Additional Information for the Condition (1) of LBLOCA SER

<LBLOCA SER p.45>

For example: Test 34006 (Flooding rate of 1.5 cm/sec)

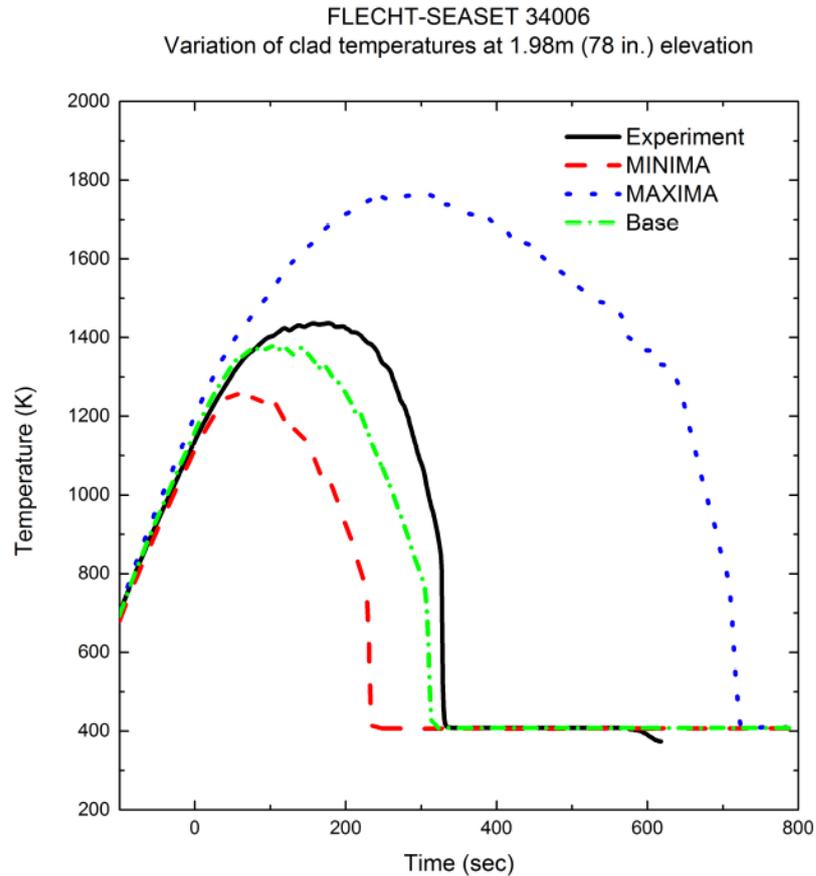
The NRC staff could not confirm the applicant's response during the January 2016 Audit Meeting. Therefore, the NRC staff imposes Condition (1) on the use of CAREM:

Should changes to the APR1400 configuration, evaluation model, or design input result in large break LOCA flooding rates lower than 10 cm/sec, the CAREM analyses shall require additional justification and NRC approval.

The phrase of condition (1) need to be deleted or modified because of the following reasons:

CAREM follows best-estimate with uncertainty propagation approach.

- For each code assessment against test data, the calculated cladding temperature of the base case calculation does not need to cover the maximum measured data based on the best-estimate approach.
- The purpose of base case calculation is to confirm the general thermal-hydraulic behaviors and the code predictability (or code accuracy) by evaluating PCT difference between calculated and measured values.
- The code accuracy obtained from base case calculation is used to estimate the degree of uncertainties.
- On the other hand, the 3rd highest PCT of SRS calculation is checked whether the selected uncertainty parameters and their ranges can cover the maximum measured PCT or not in the Experimental Data Covering (EDC) step of CAREM.

- Based on the best-estimate with uncertainty propagation approach, if the 3rd PCT can cover the maximum measured PCT, it concluded that selected uncertainty parameters and their ranges are appropriate.
- The other assessment results for low flooding rate tests show that calculation results by best-estimate with uncertainty propagation approach can cover the maximum measured PCTs as shown in below:

Calculation results by best-estimate with uncertainty propagation approach

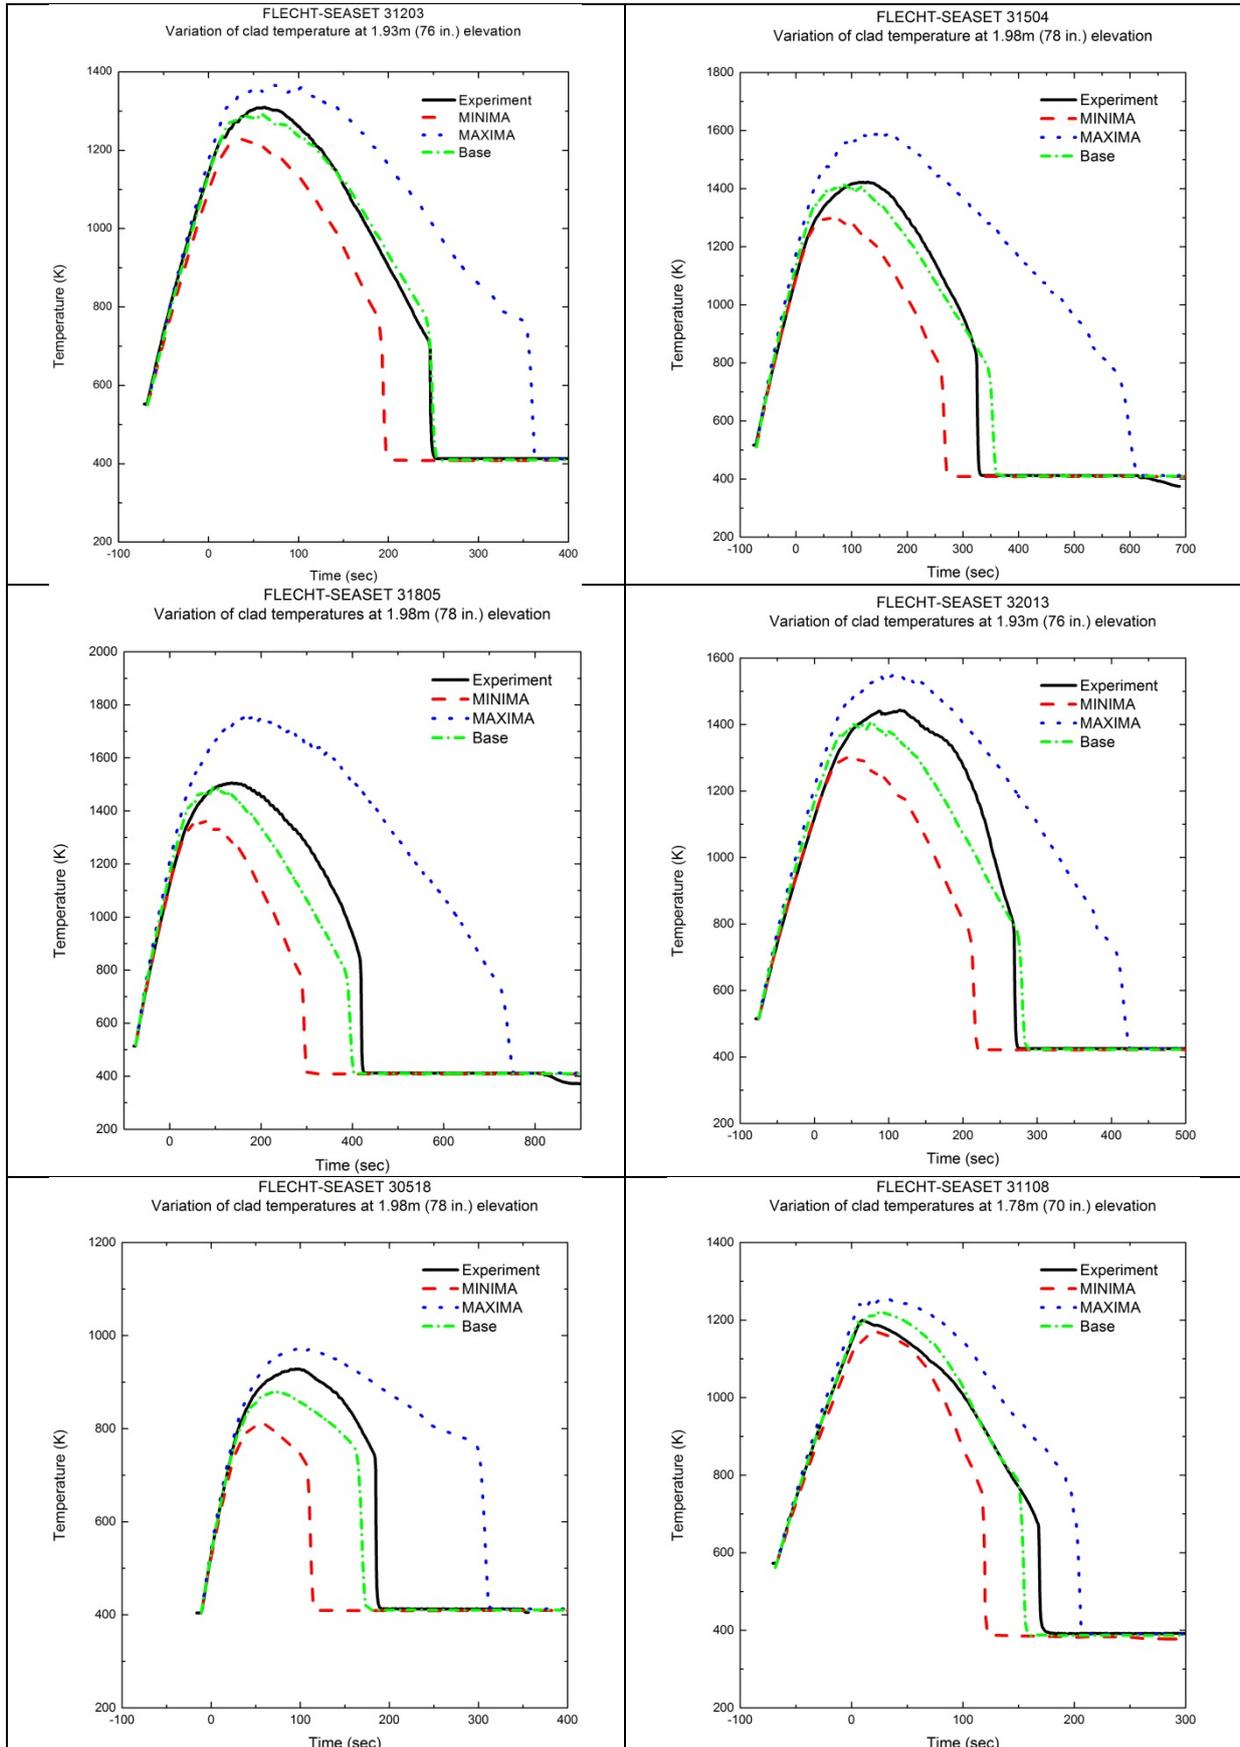
FLECHT-SEASET Test Number	Flooding Rate (cm/sec)
31203	3.84
31504	2.46
31805	2.1
32013	2.64
30518	3.89
31108	7.9

- Consequently, although some of base calculation results for FLECHT-SEASET underestimate the maximum measured PCTs, it can conclude that best-estimated code results with uncertainty propagation have conservatism because the 3rd highest PCTs for all 17 test cases cover the maximum measured PCTs.

Code assessment results for low flooding rate tests show that the best-estimate with uncertainty propagation approach of CAREM has sufficient conservatism to predict PCT.
